APPLICATION NO.	FILING DATE	FIRST NAMED INVENTOR	ATTORNEY DOCKET NO.	CONFIRMATION NO.
10/555,156	11/02/2005	Naoki Fujiwara	14321.81	3941
22913	7590	08/23/2007		
WORKMAN NYDEGGER 60 EAST SOUTH TEMPLE 1000 EAGLE GATE TOWER SALT LAKE CITY, UT 84111			EXAMINER PARK, KINAM	
			ART UNIT 2828	PAPER NUMBER
			MAIL DATE 08/23/2007	DELIVERY MODE PAPER

Office Action Summary	Application No. 10/555,156	Applicant(s) FUJIWARA ET AL.	
	Examiner Kinam Park	Art Unit 2828

DETAILED ACTION

Fig. 1. Schematic structure of the mode-hop-free DBR laser.

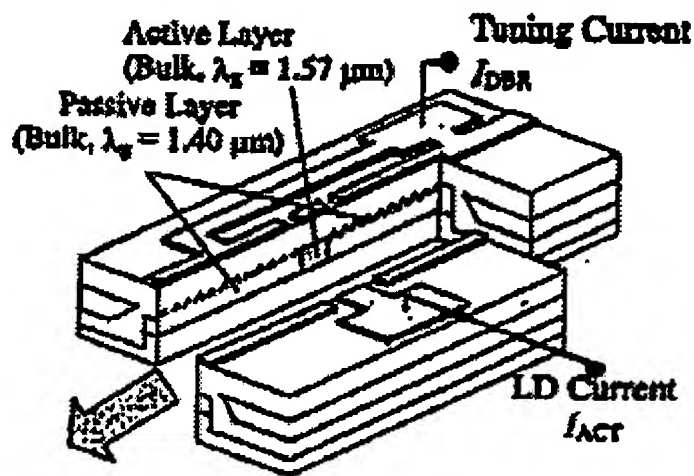
Fujiwara et al. discloses in figure 1 and specification:

a first passive region optical waveguide (see, Passive Layer) including a first DBR region having a diffraction grating in a section whose length corresponds to effective length of 95% or more in a saturated effective length value (see, figure 3 & 4), wherein the lasing wavelength is controlled by a DBR control current (see, I_{DBR}),

a second passive region optical waveguide (see, Passive Layer) including a second DBR region having a diffraction grating in a section whose length is shorter than the first DBR region (see, figure 3 & 4), wherein the lasing wavelength is controlled by the DBR control current (see, I_{DBR}), and

an active region optical waveguide (see, Active Layer) in which the first passive region optical waveguide and the second passive region optical waveguide are optically connected at both ends, wherein emission state is controlled by the active region current (see, I_{ACT}), irrespective of the DBR control current.

Regarding claim 13-15, 17-19, 21, 23, 25-26, 28, 30-32, 34, 36-38, 40, Note that Fujiwara et al. discloses in figure 1 and specification a first electrical isolating region and a second electrical isolating region (see, the separation of electrode) (**claim 13, 30, 36**), the length of active region in a range from $30 \mu\text{m}$ to $100 \mu\text{m}$ (see, figure 5) (**claim 15, 17-18, 21, 23, 25-26, 31-32, 37-38**). The effective length of the second DBR region of 75% or less (**claim 14, 19**) in the saturated effective length value and the ratio of the lasing wavelength shift quantity to the Bragg wavelength shift quantity in a range from 0.9 to 1.1 (**claim 28, 34, 40**) are insignificant in this art since these can be controlled by coupling coefficient of corrugation grating and the length of DBR gating (see, figure 3 & 4).

Fig. 12. Structure of the 4-ch mode-hop-free DBR laser array.

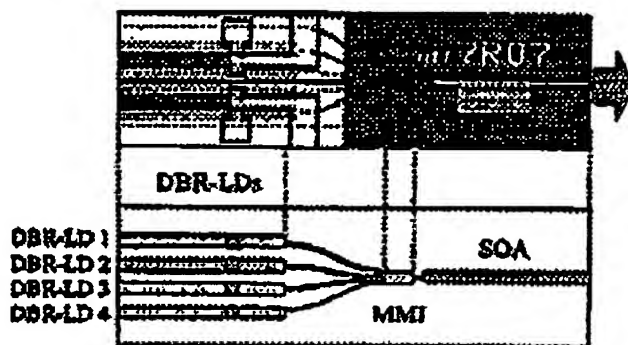
Fujiwara et al. also discloses in figure 12, an optical coupler (see, MMI) and an optical semiconductor amplifier (see, SOA).

However, Fujiwara et al. is silent as to the plurality of wavelength tunable DBR laser having different pitches of the diffraction grating.

Ikeda et al. discloses the diffraction grating with different grating (see, col.1, lines 15-22).

Therefore, it would have been obvious to a person of ordinary skill in the art at the time of invention to combine the diffraction grating with different grating of Ikeda et al. with a wavelength tunable DBR laser of Fujiwara et al because this provides a plurality of laser light beams having different wavelengths (see, col.1, lines 15-22 of Ikeda et al.).
